## ADDENDUM NO. 2

**PROJECT NAME:** Wick Alumni Center Life Safety & HVAC Improvements  
**UNL PROJECT NUMBER:** C120P021  
**BID INVITATION NUMBER:** 2222-13-7200

**CONSULTANT:** Farris Engineering  
**ADDRESS:** 818 P Street, Suite 100

**DATE OF ISSUANCE:** September 11, 2013  
**DATE OF BID OPENING:** September 18, 2013

**SHEET NO**  
**M1-1**

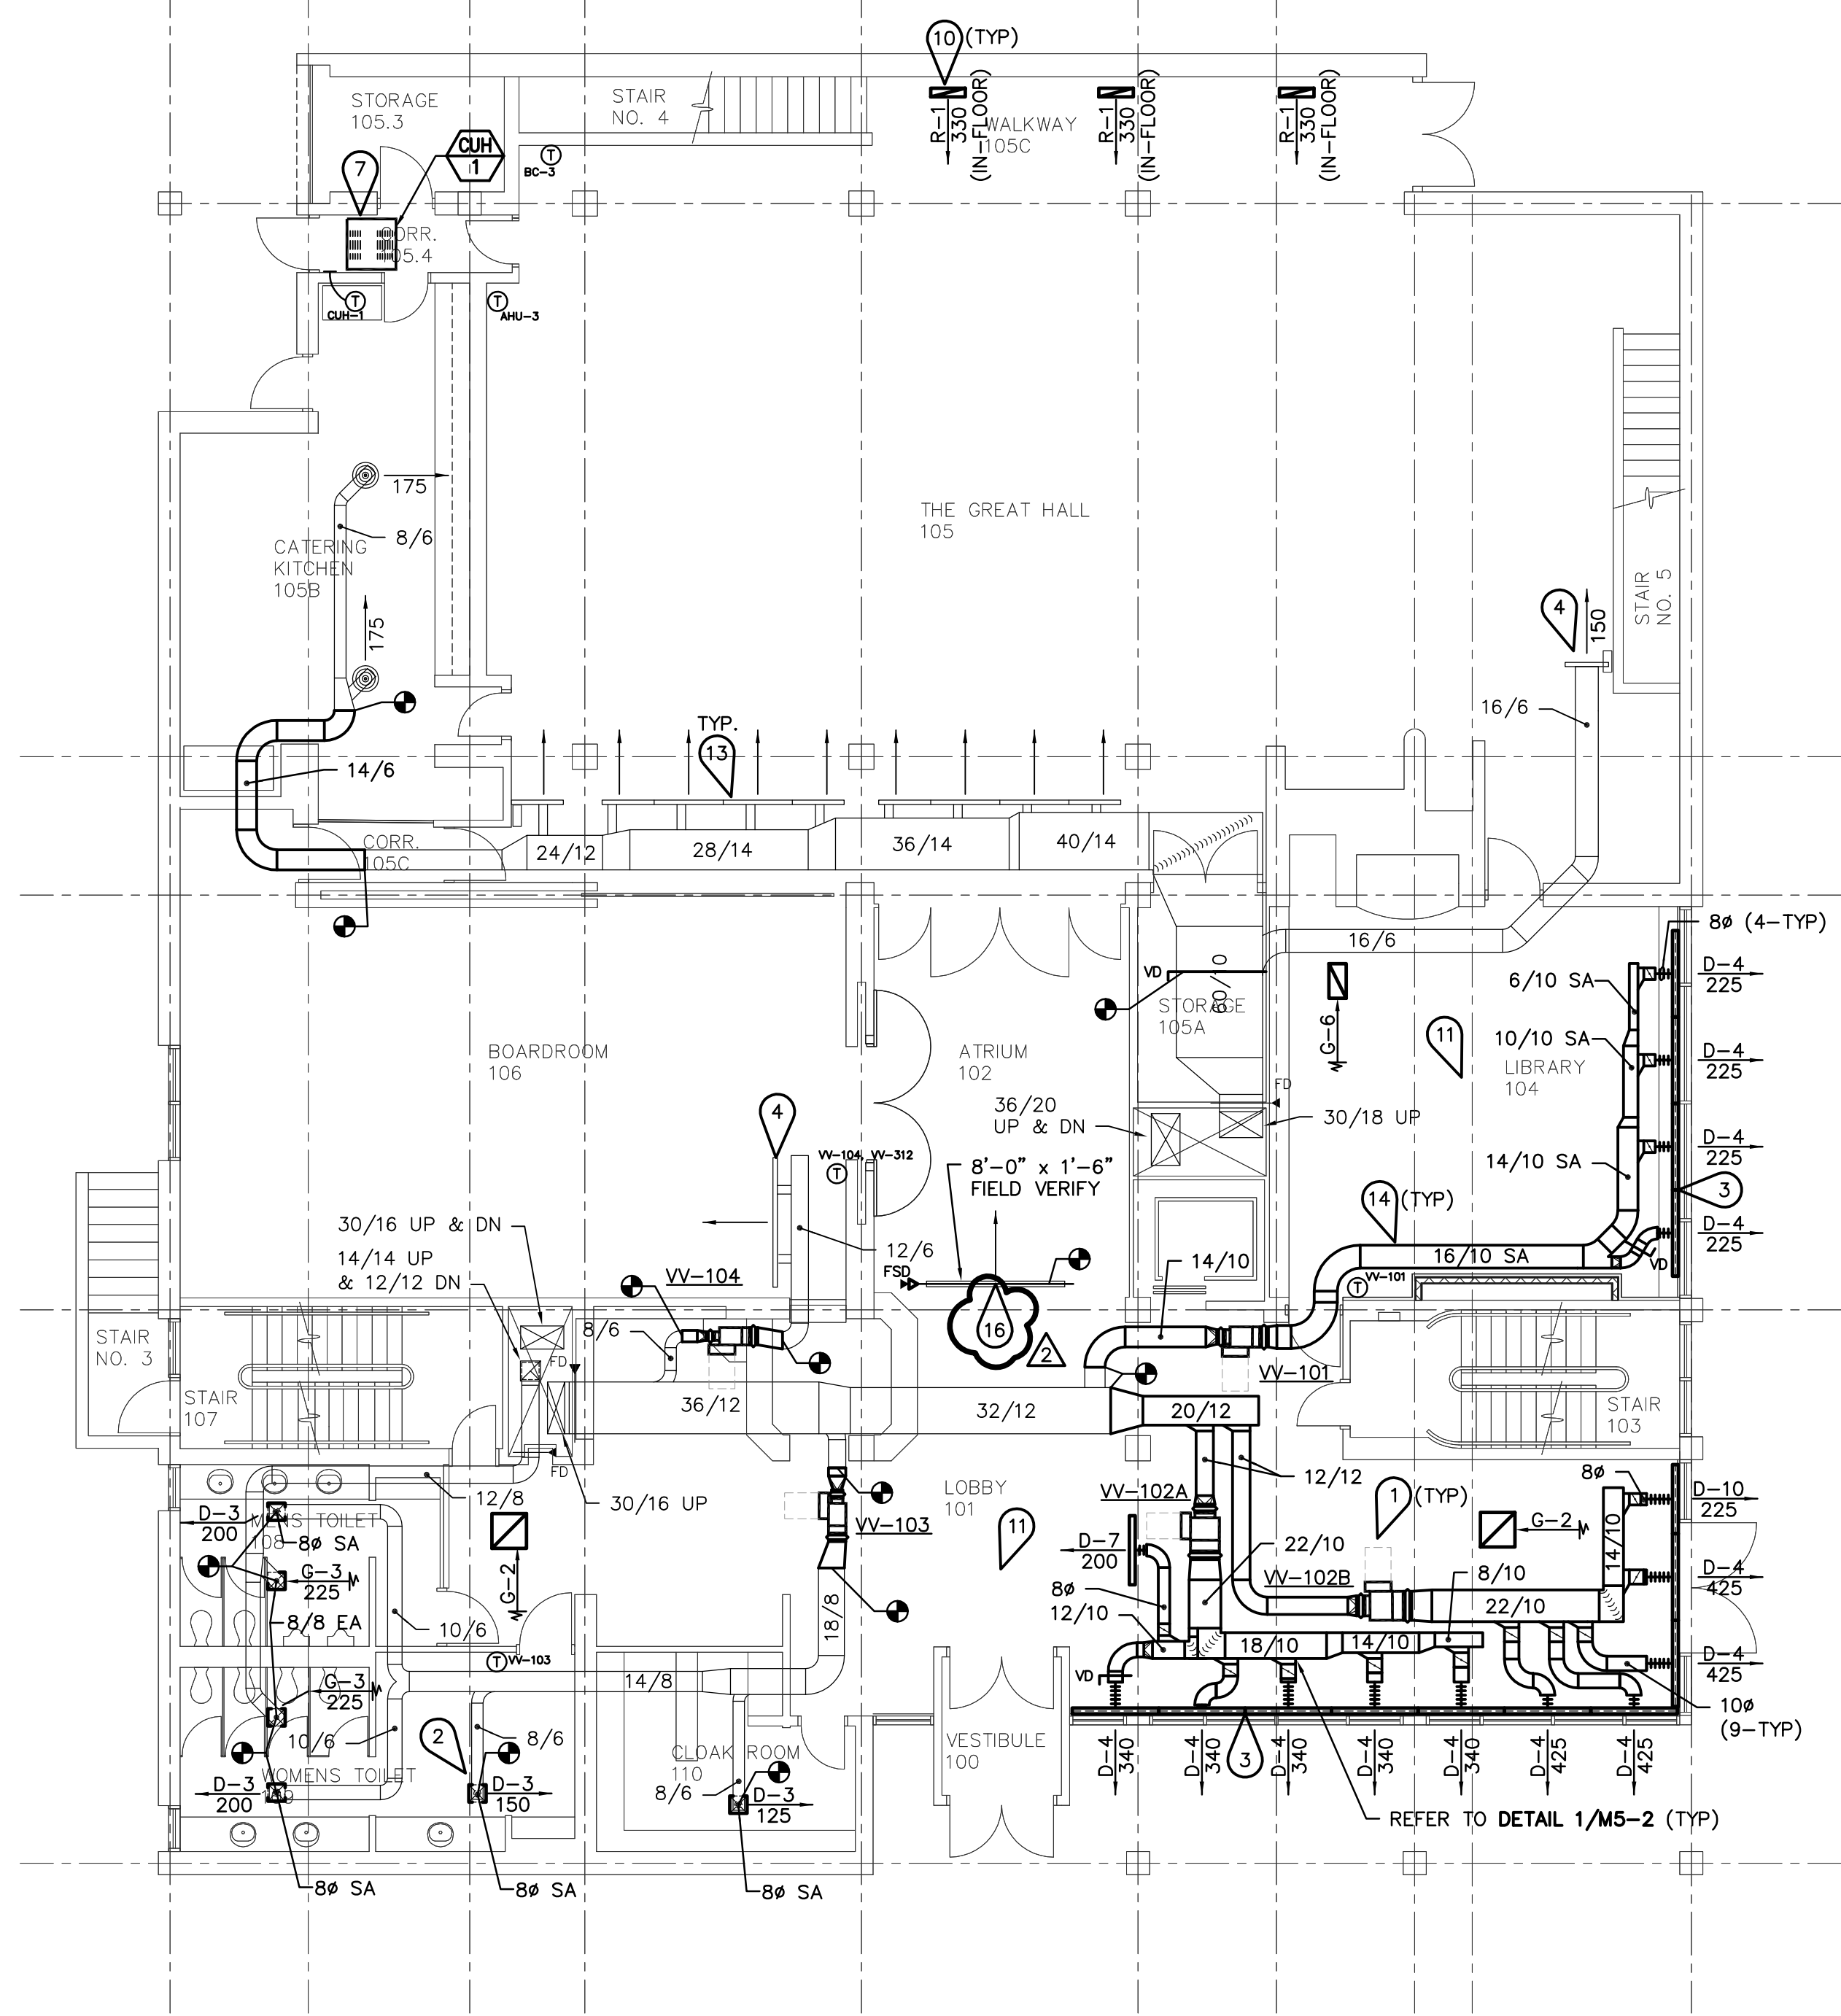
1. This sheet has been reissued in its entirety as a part of Addendum No.2.
2. Mechanical Keynote #5 has been revised.
3. "THIRD FLOOR HVAC PLAN" has been revised to change keynote #5 to keynote #11 on the plans.
4. Mechanical Keynote #11 has been added.
5. Revised diffuser tags from "D-3" to "D-7" in Rooms 209 and 311.

SHEET NO  
**M1-2**

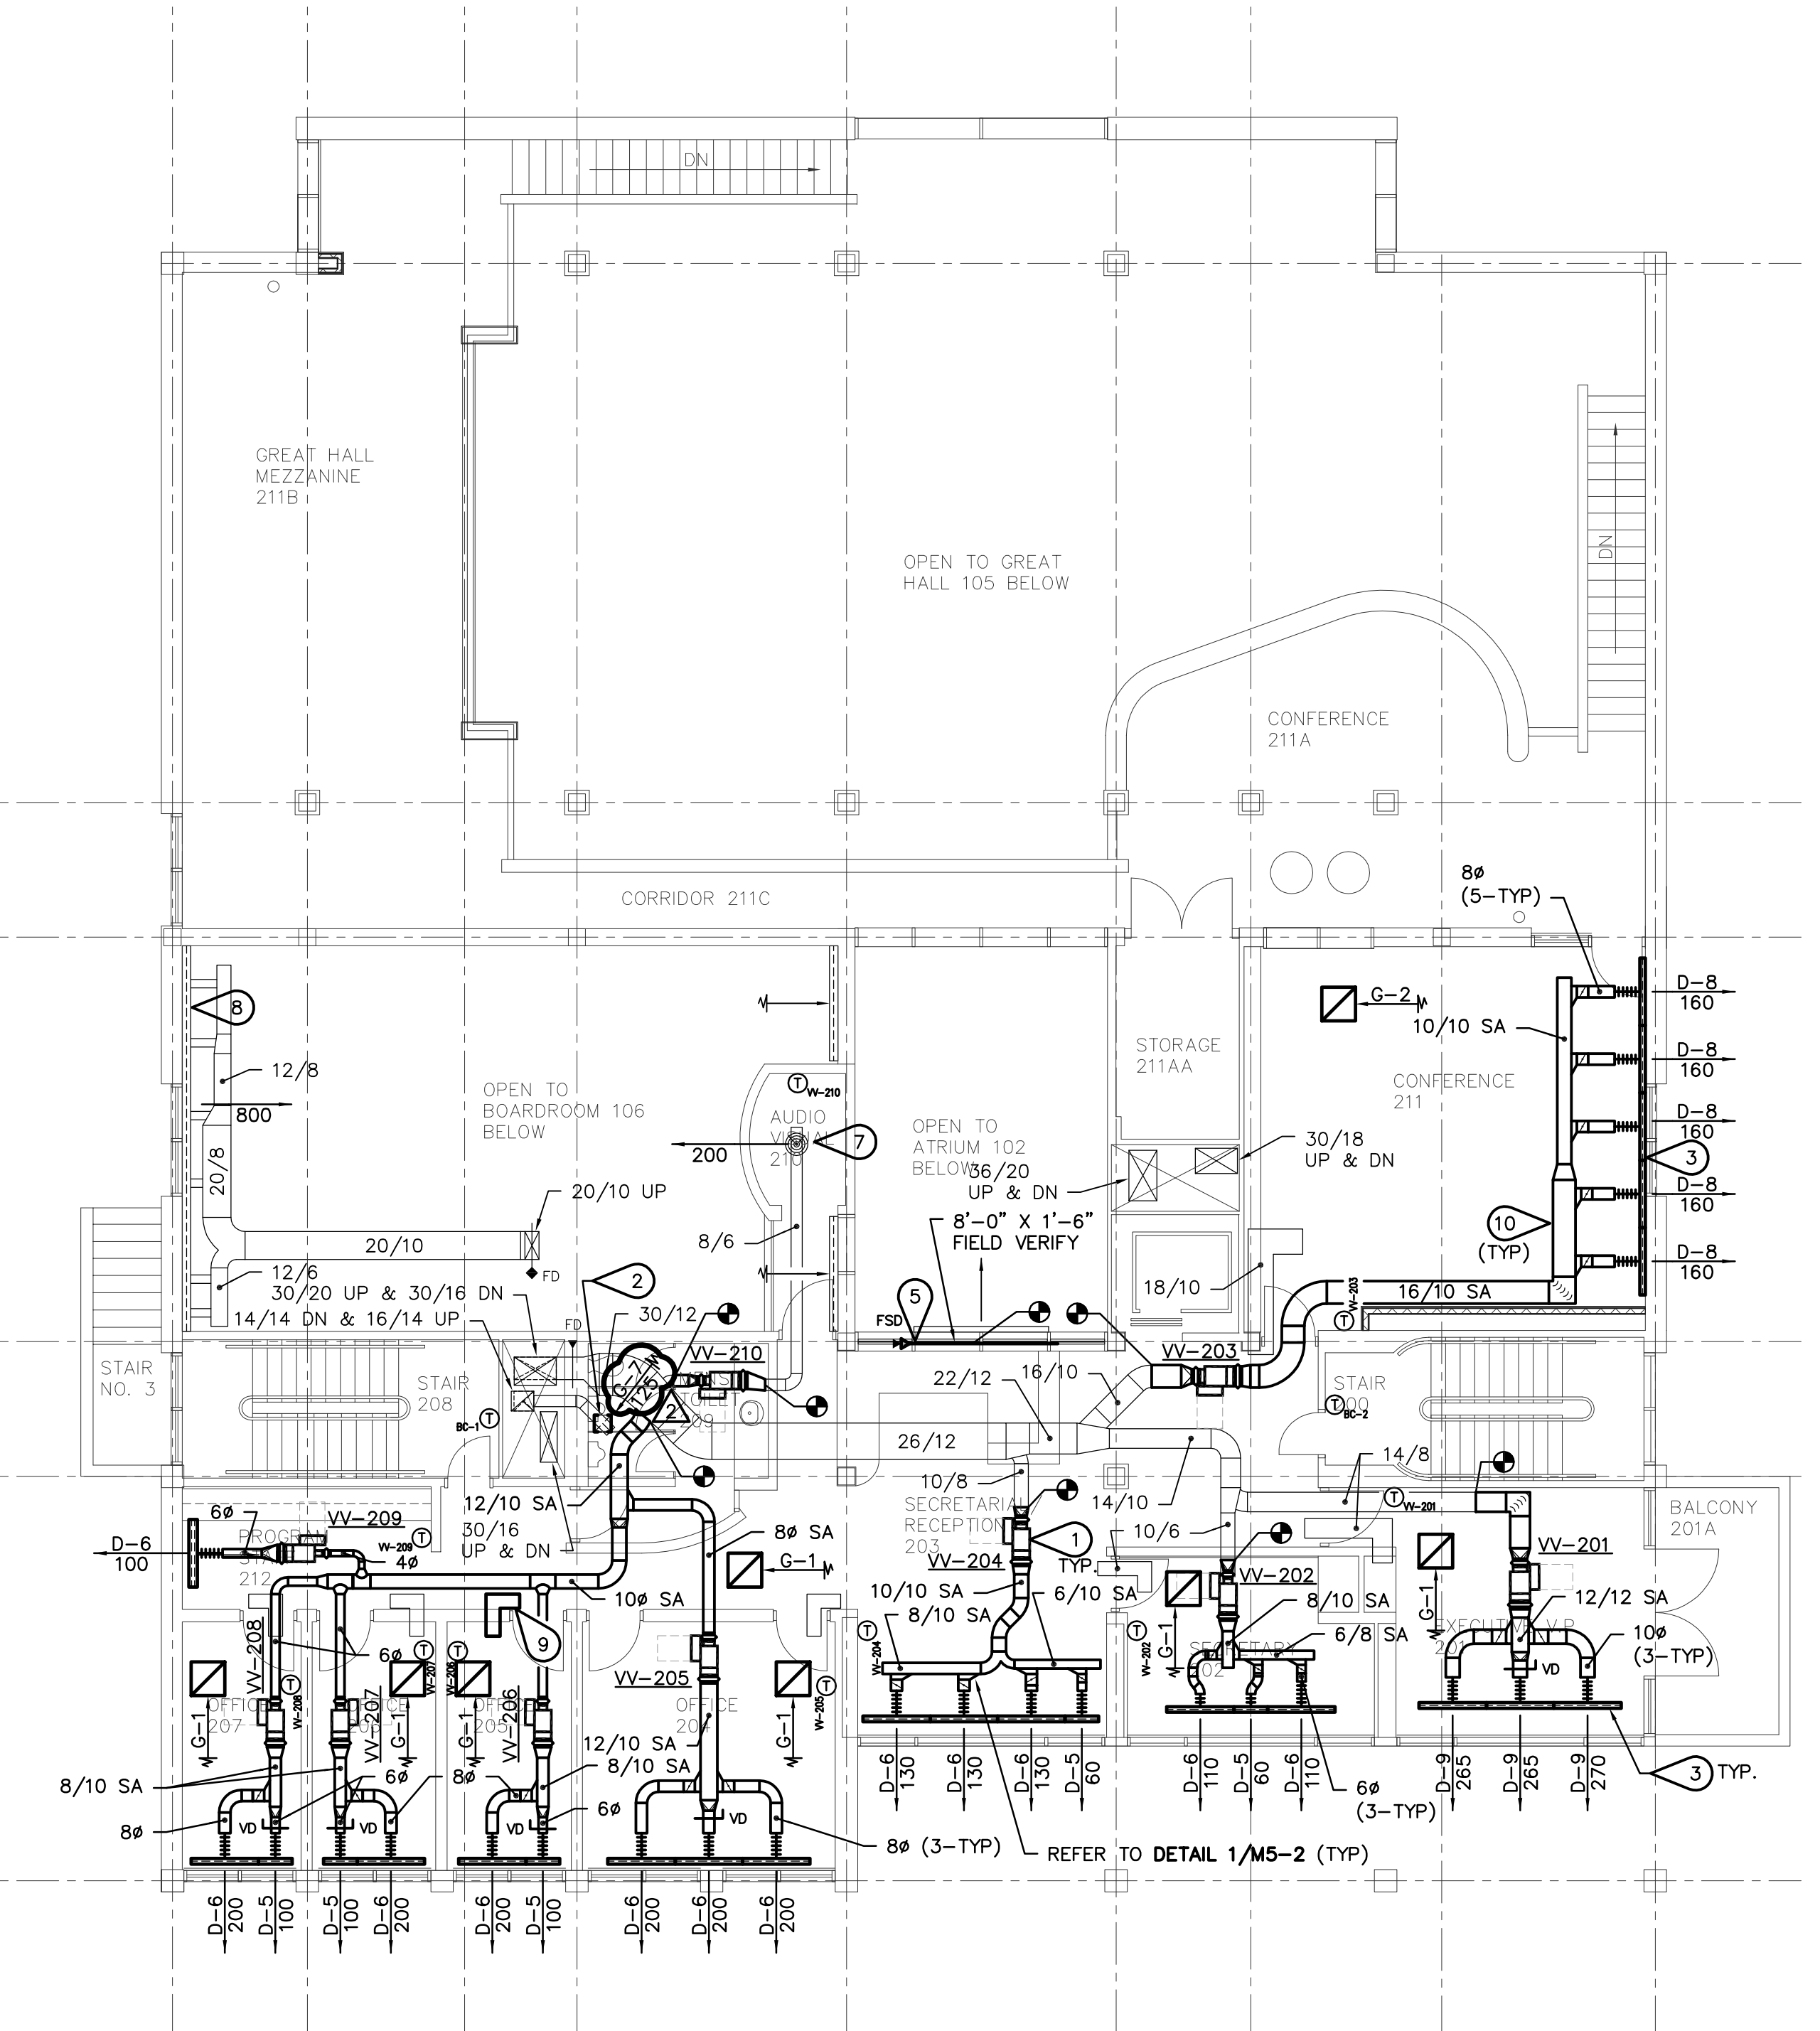
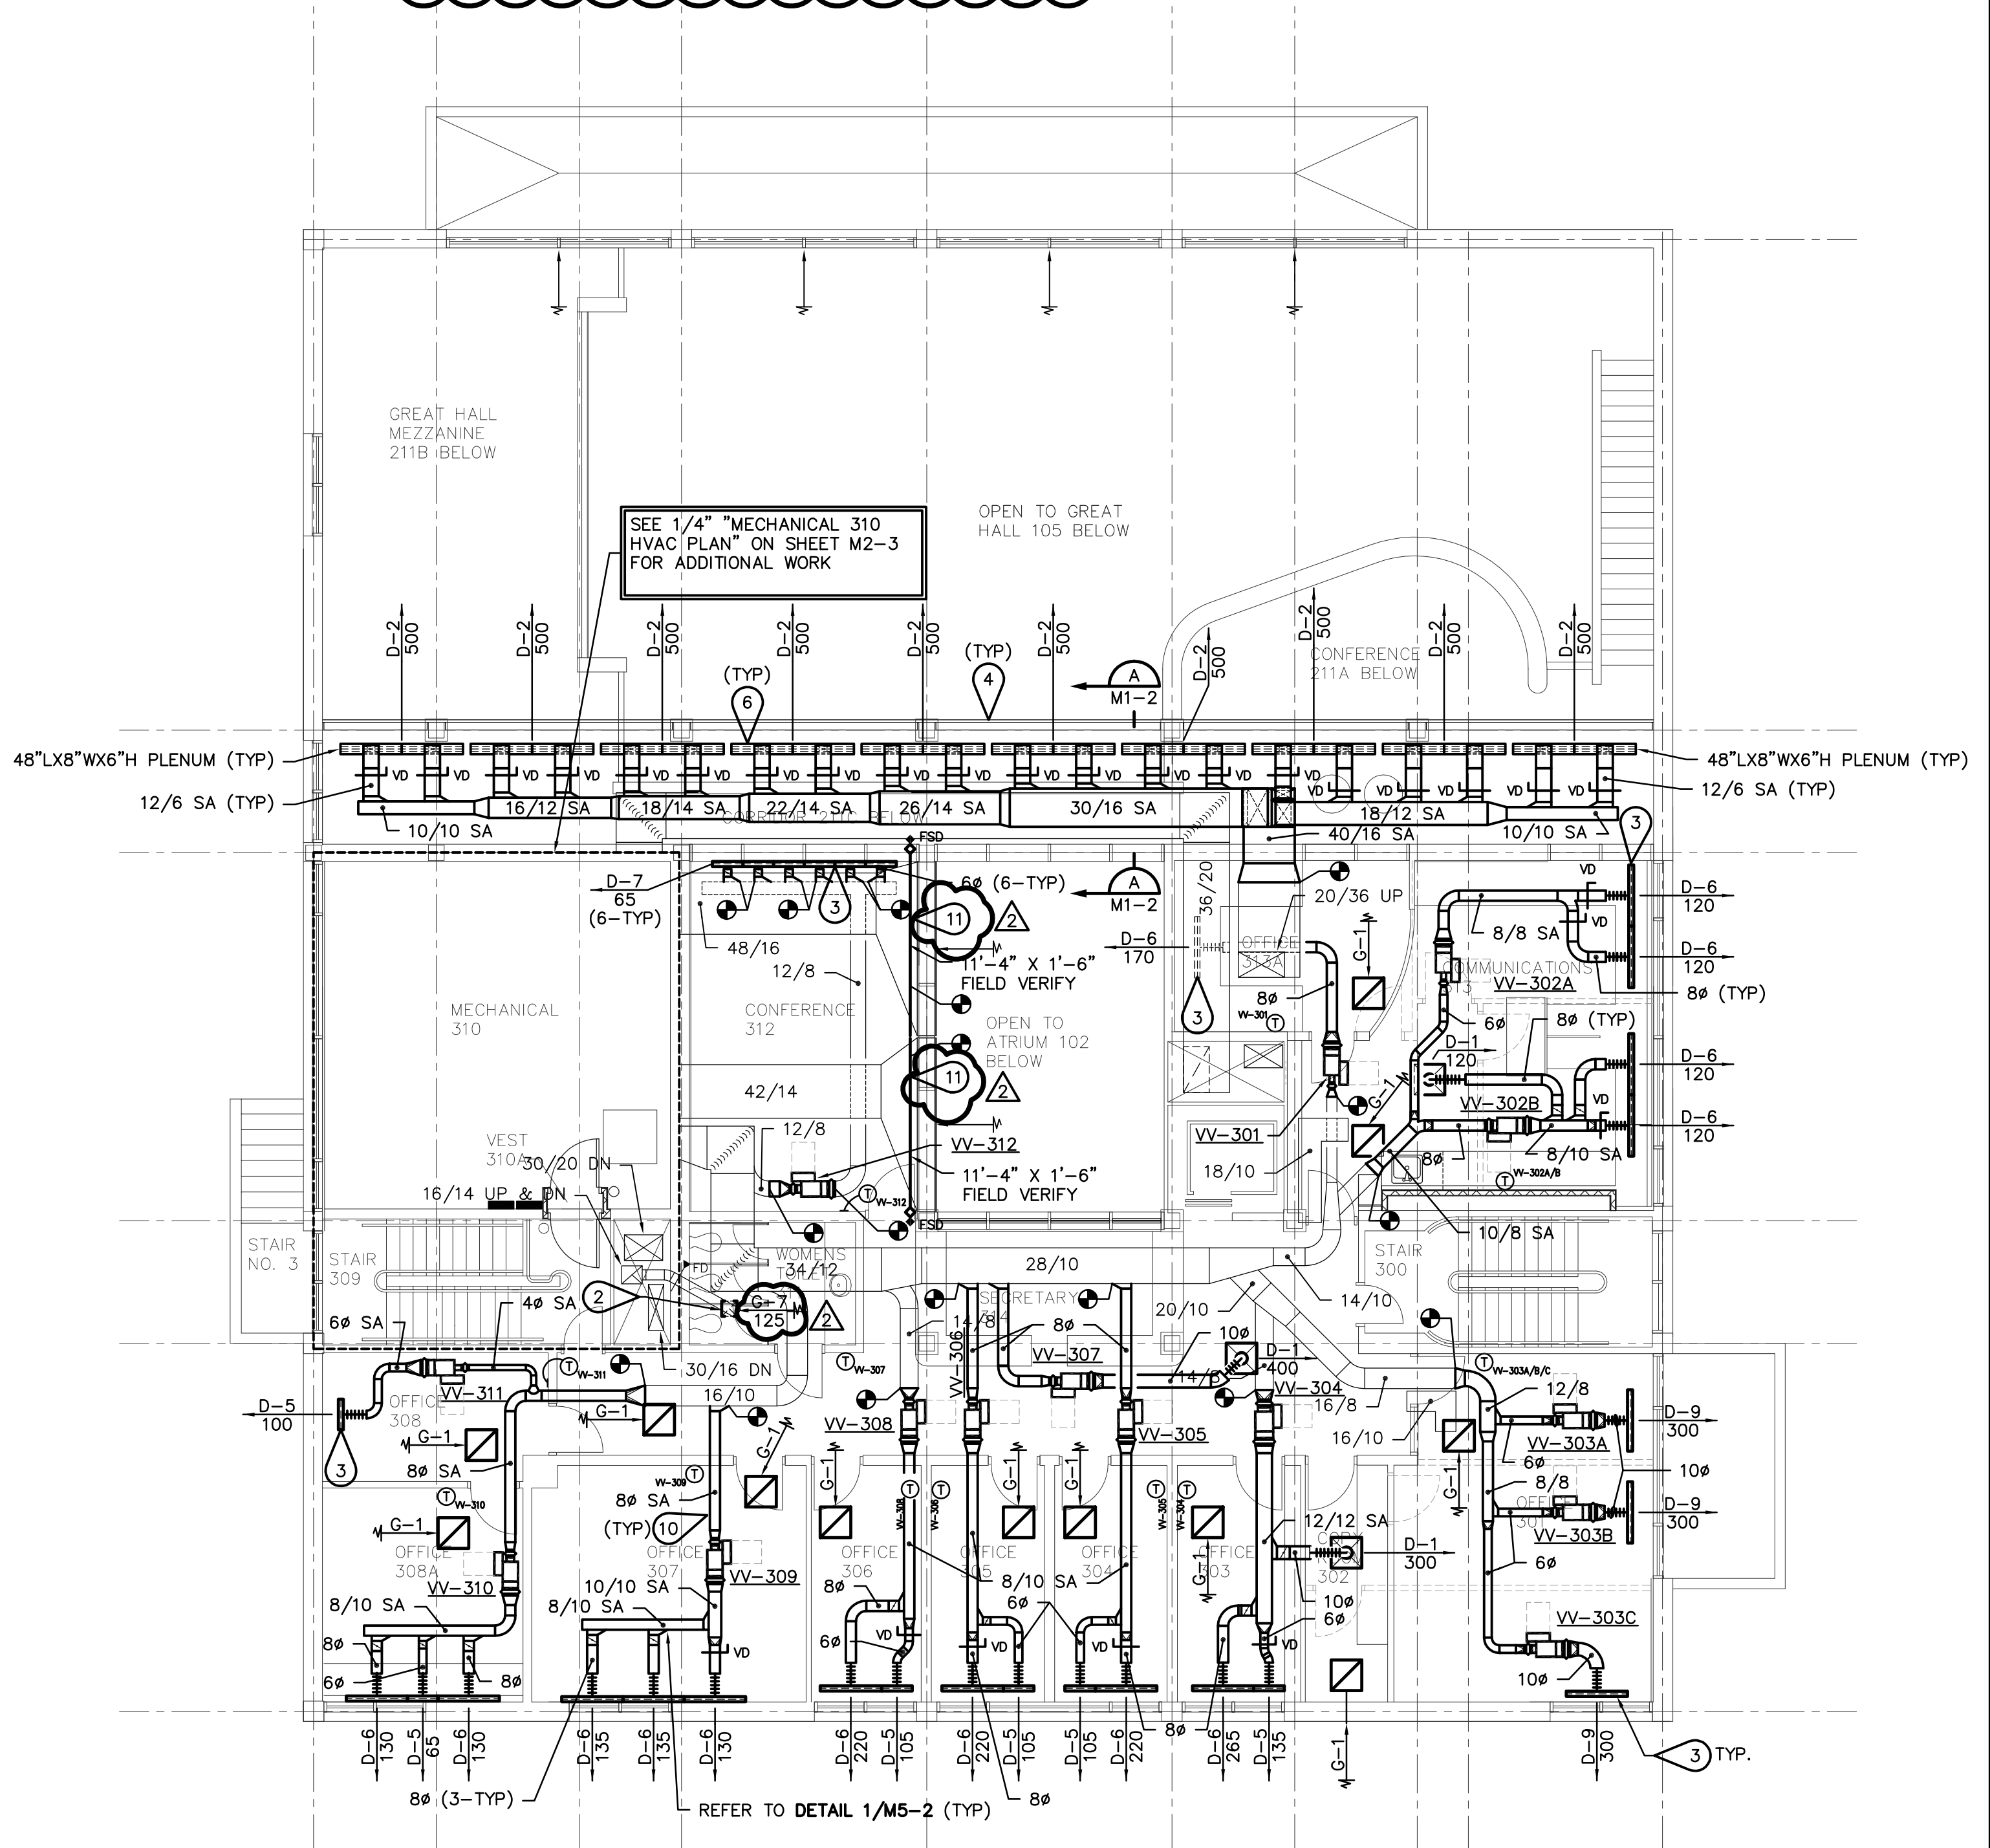
1. This sheet has been reissued in its entirety as a part of Addendum No.2.
2. Mechanical Keynote #5 has been revised.
3. "FIRST FLOOR HVAC PLAN" has been revised to change keynote #5 to keynote #16 on the plans.
4. Mechanical Keynote #16 has been added.
